Incoming
CO250005
#3371
K

From: <petersen@relia.net>
To: "Jim Smith" <jimdsmith@utah.gov>
CC: <petersen@relia.net>
Date: 10/13/2009 8:28 AM
Subject: Re: Coal Hollow
Attachments: Figure 17 Pump test drawdown plot.pdf

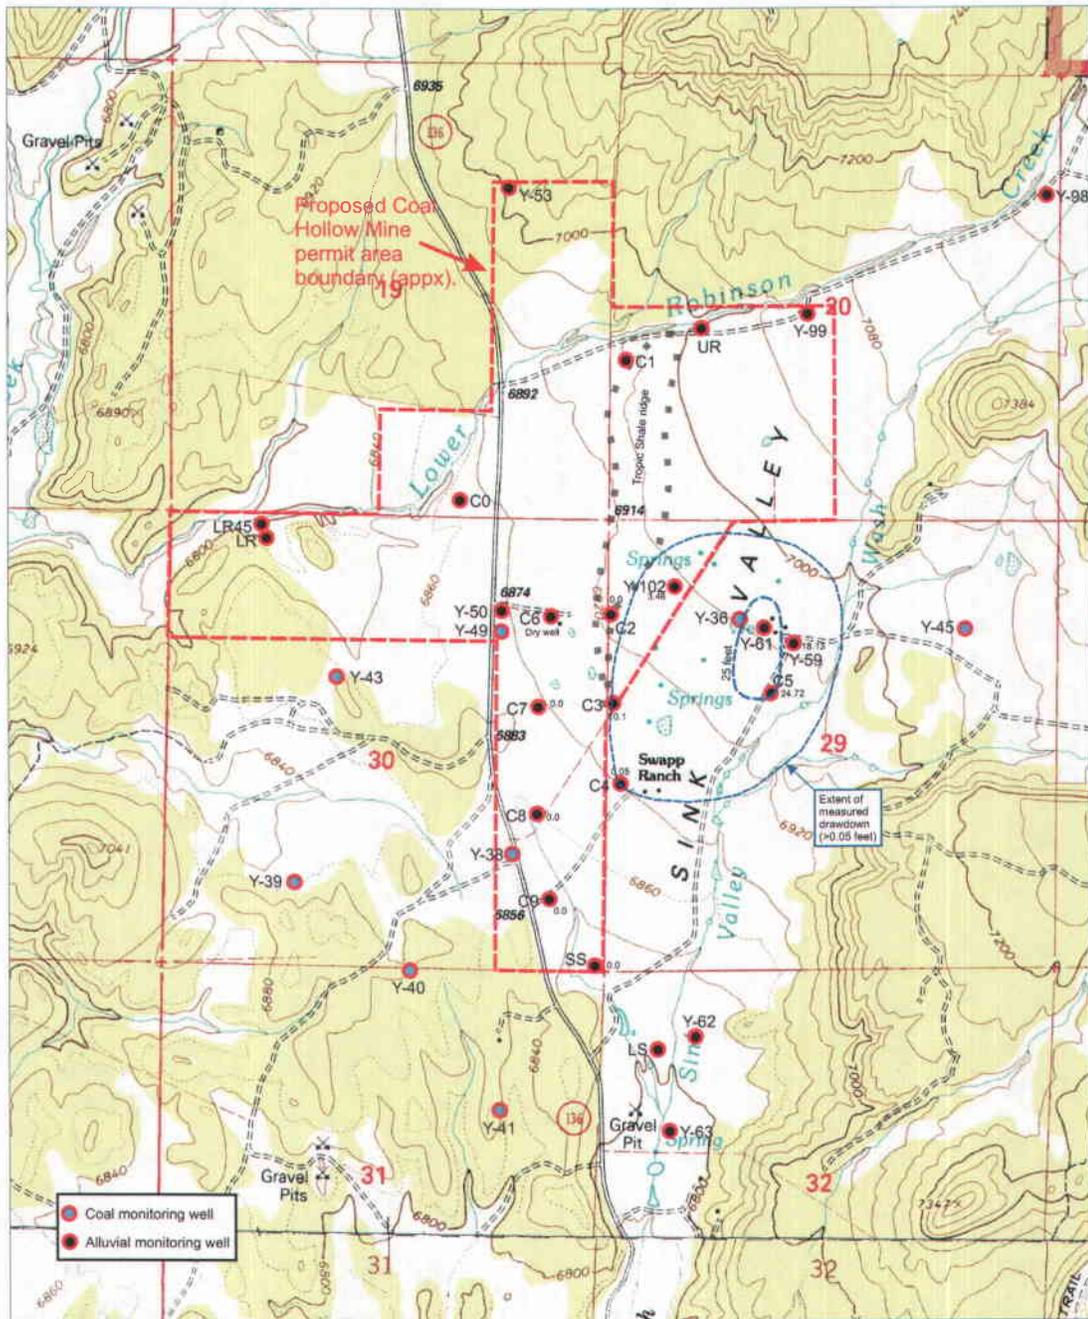
>> In the Aug 27 submittal, you've added a discussion of the Y-61 pump

>> test at the end Appendix 7-7; is that the response to my request for

>> R645-301-724.500, The Applicant needs to provide a map of the cone of depression or set

>> maps illustrating the size and shape of the cone of depression

>> the pump-drawdown test at Y-61 (Figure 18 in Appendix 7-1 indicates

>> during the pump test, water levels actually increased at SP-8 and

>> and flow increased at C2-40 after 4 hours of pumping)

Hi Jim. Here is a copy of Figure 17 to Appendix 7-7 that shows the drawdown for the Y-61 pump test. This figure will be formally submitted to DOGM on Wednesday. Let me know if you have any other questions.

> I checked this one out and discovered that the figure I created to

> the Y-61 pump test drawdowns somehow didn't get included in the

> August 27th submittal. It will be included in the next submittal. As
